## SUBMITTAL SUMMARY REPORT MajorSite-000555-2026

<b>PLAN NAME:</b> Pardee Maricamp Storage	<b>LOCATION:</b> 0
<b>APPLICATION DATE:</b> 03/27/2026	<b>PARCEL:</b> 31385-000-00
<b>DESCRIPTION:</b> Construction of a self-storage facility with associated driveways, stormwater improvements, and utilities under a PUD Rezoning. Site is on the south side of SE Maricamp Road between the Cross Florida Greenway and Rotary Sportsplex.

SHEET NUMBER  
C08

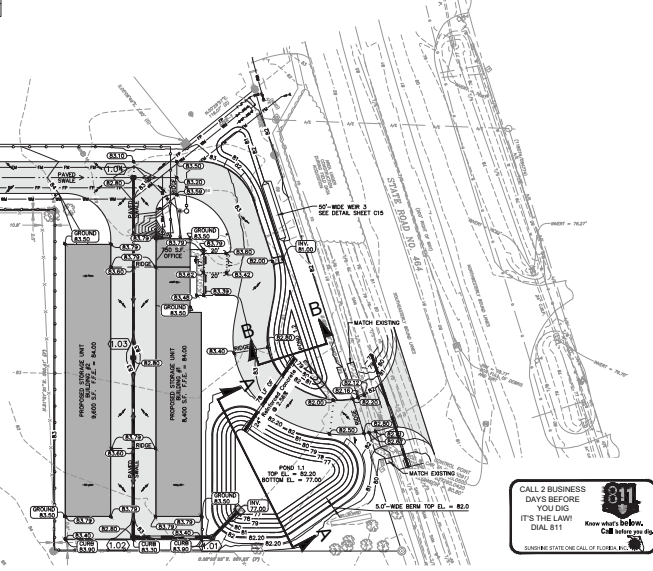
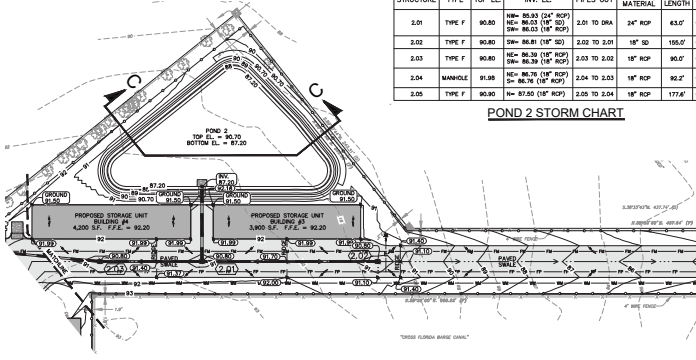
*Corrections* Additional 911 Comments (**Not Resolved**) - **Corrective Action:** Correct road names on future submittals. - Sheet C01 under Site Data - Project Location has SE Maricamp Rd listed incorrectly as SW Maricamp Rd. Sheets C03, C04, C06, C08, C11, C13, and C14 has SE Maricamp Rd incorrectly listed as State Road 484. C17 has SE Maricamp Rd incorrectly listed as SR 464.
